CM CLARIFICATION BULLETIN #4

BULLETIN NO:	FOUR (4)	DATE:	February 23, 2024
PROJECT:	SSUSD – ORNAMENTAL FENCE AT FALLER ELEMENTARY SCHOOL		
PROJECT NO:	CCC #23-015		
DISTRICT:	SIERRA SANDS UNIFIED SCHOOL DISTRICT		
ARCHITECT:	ORDIZ-MELBY ARCHITECTS		
CONSTRUCTION MANAGER	COLOMBO CONSTRUCTION CO., INC. 3211 Rio Mirada Drive Bakersfield, CA 93308 661-316-0100	BID DATE:	REVISED February 28, 2024 @ 11 AM

A-121

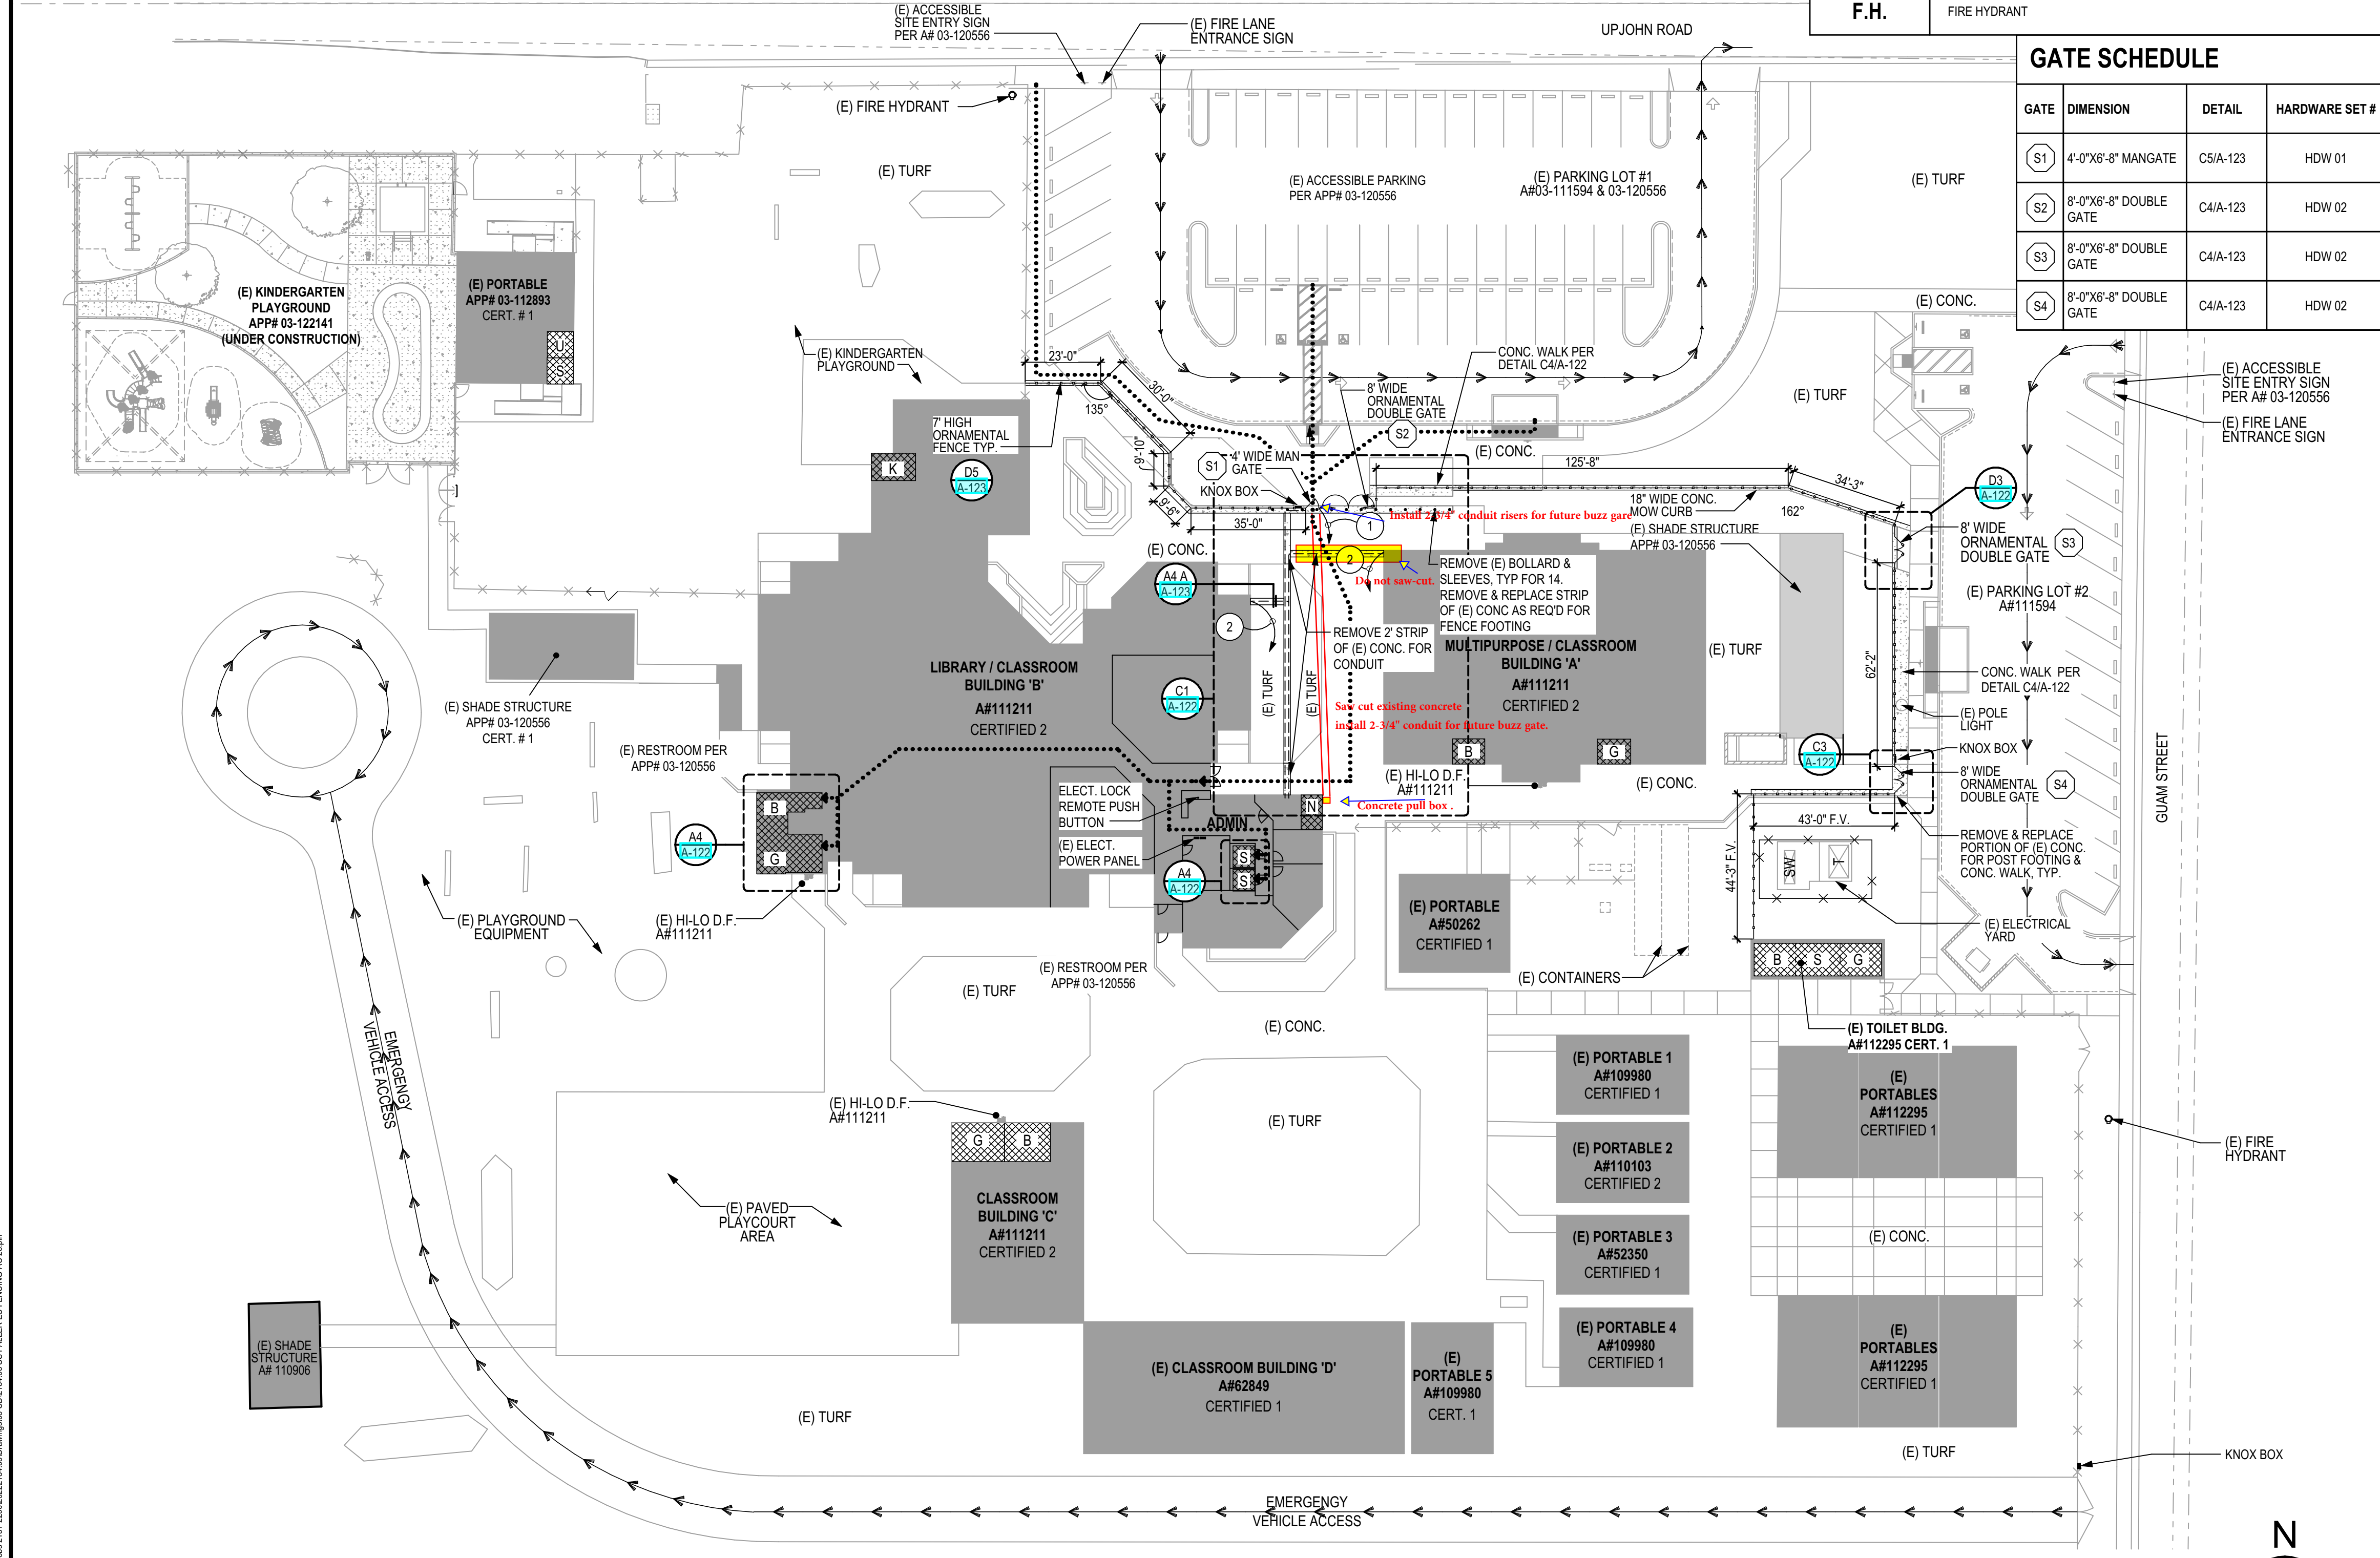
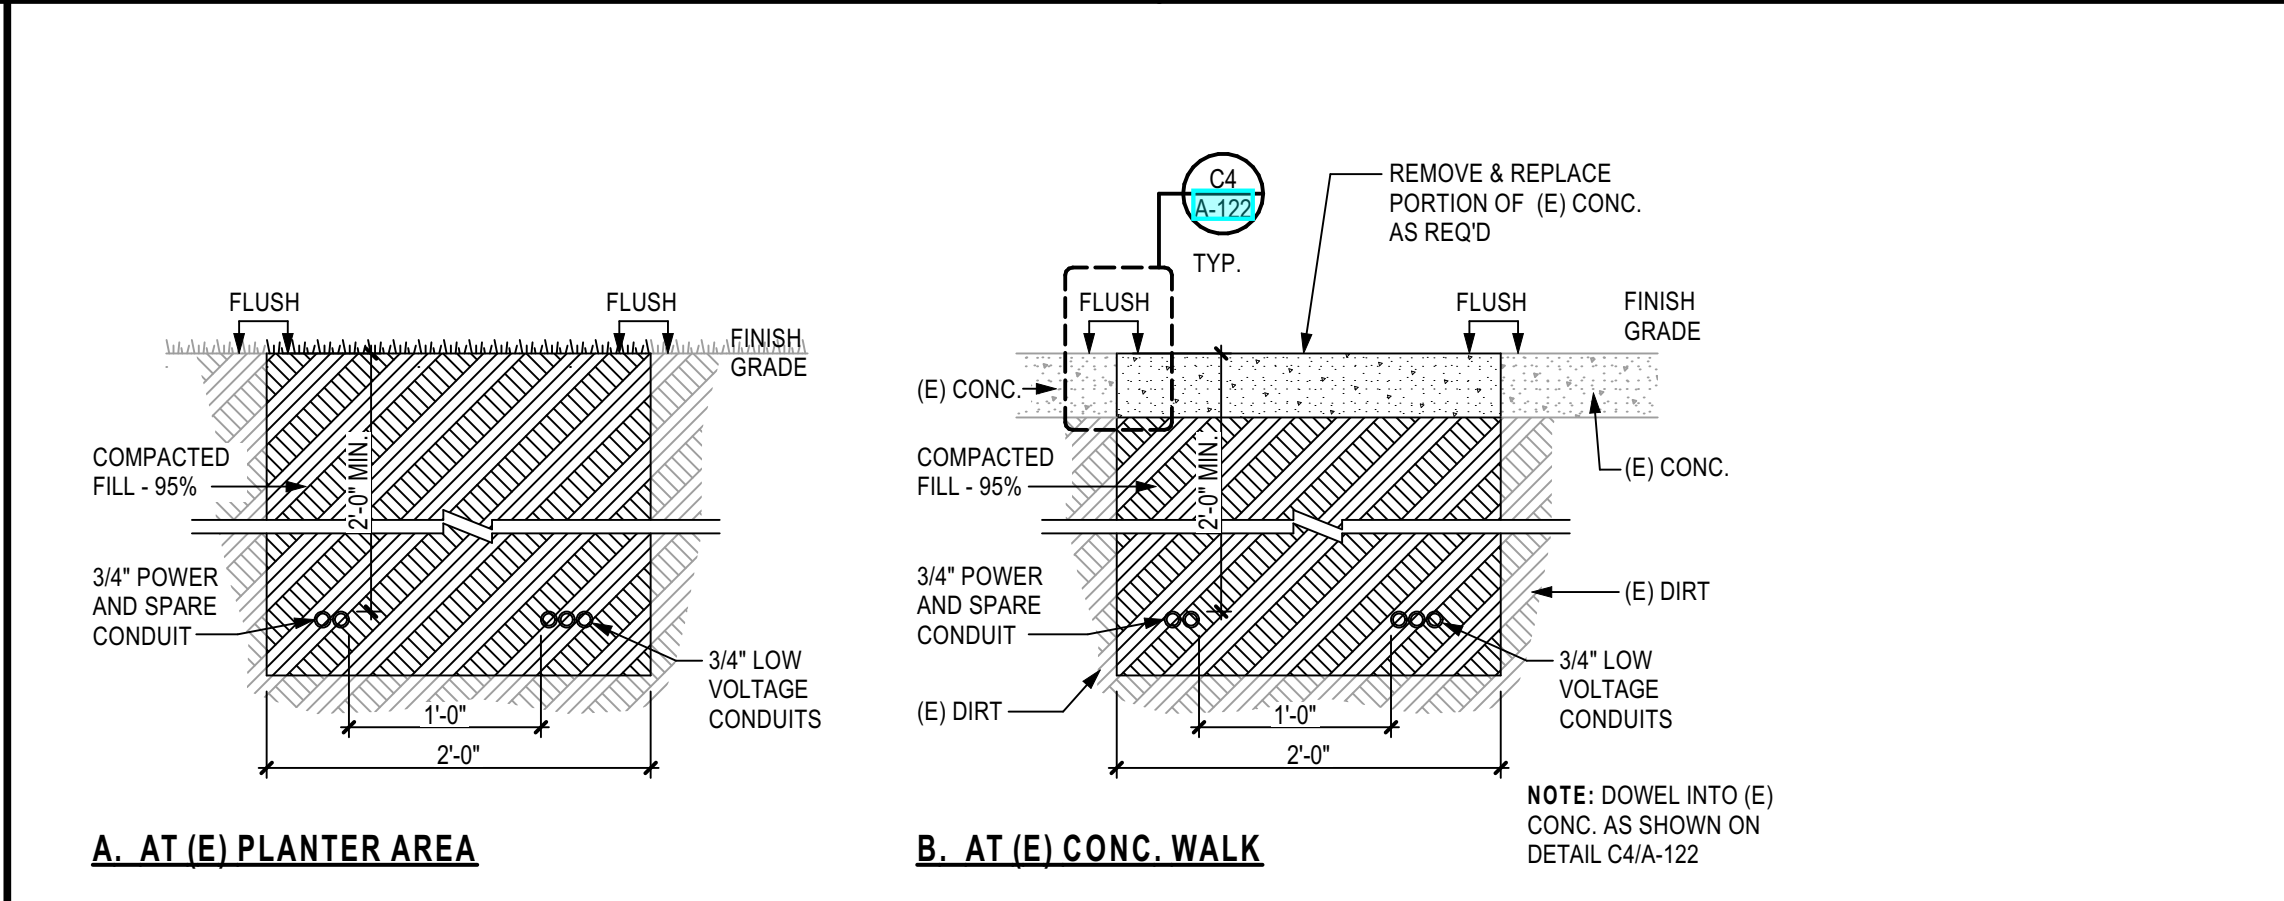
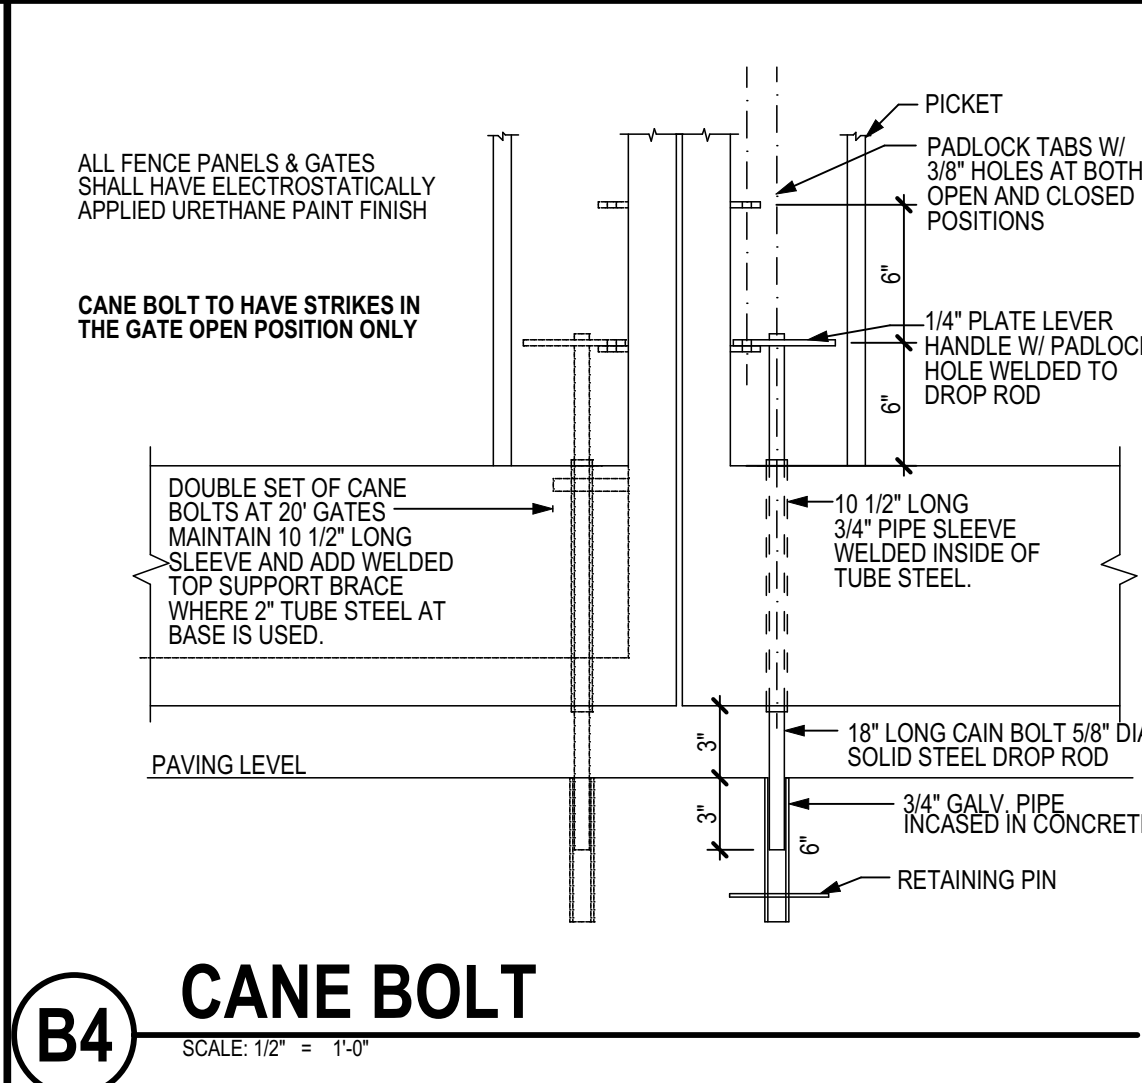
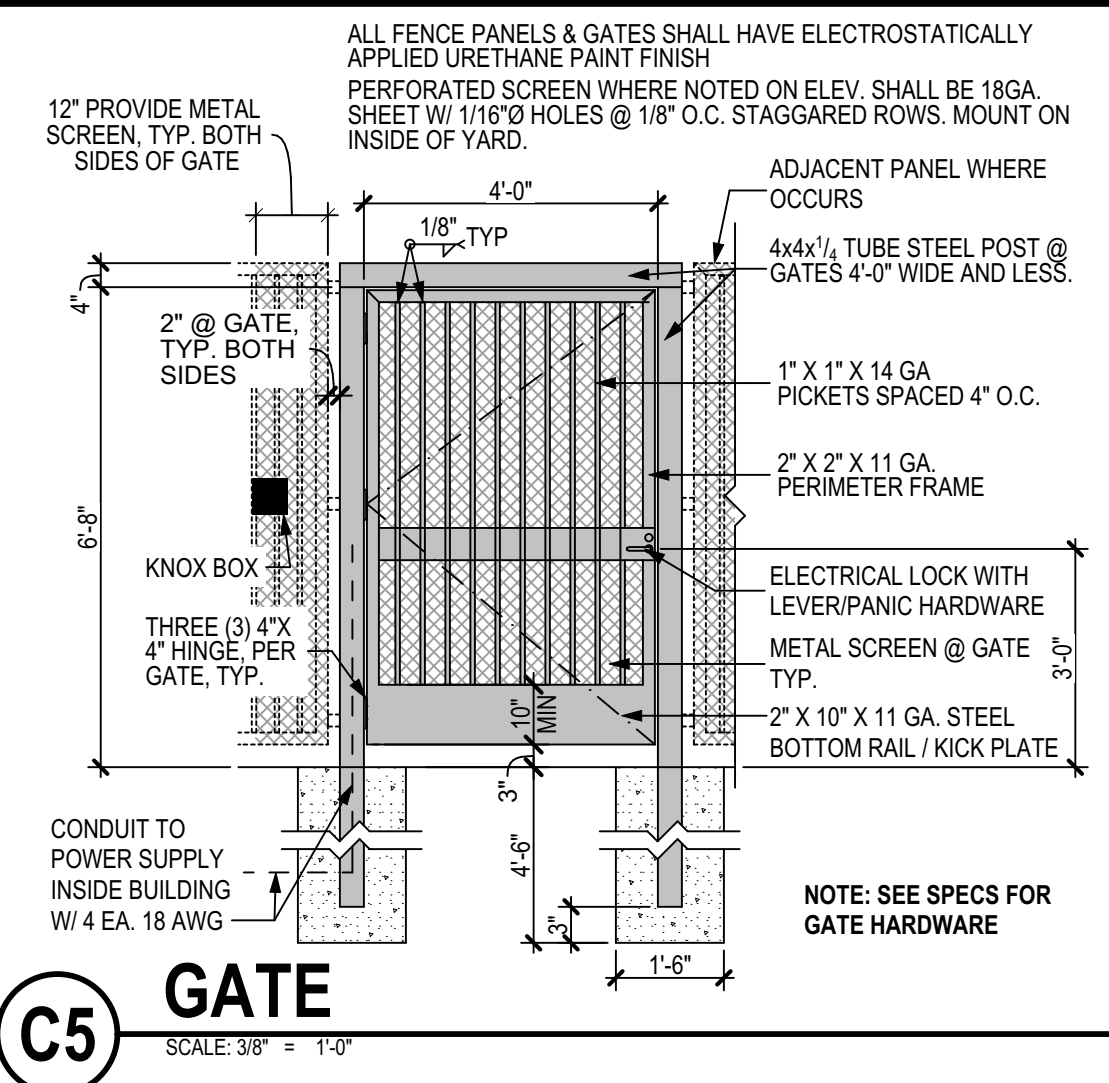
Question	<p>Question from Marisa Garza Colombo Construction Co Inc on Thursday, Feb 1, 2024 at 10:02 AM PST Confirm core drills are acceptable in concrete?</p>
Official Response	<p>Response from Kevin Dunn Colombo Construction Co Inc on Monday, Feb 19, 2024 at 10:12 AM PST There are 2 options. Option 1: core drill at all posts as needed with the exception of the removal of pipe bollards. Option 2: saw-cut full length of new fence line as needed & patch back. See clarification.</p>

Option: 1 Saw cut & core all fence post except where existing bollards will be saw-cut and removed.
 Option: 2 Saw cut a clear path 18" wide full length of fence line.
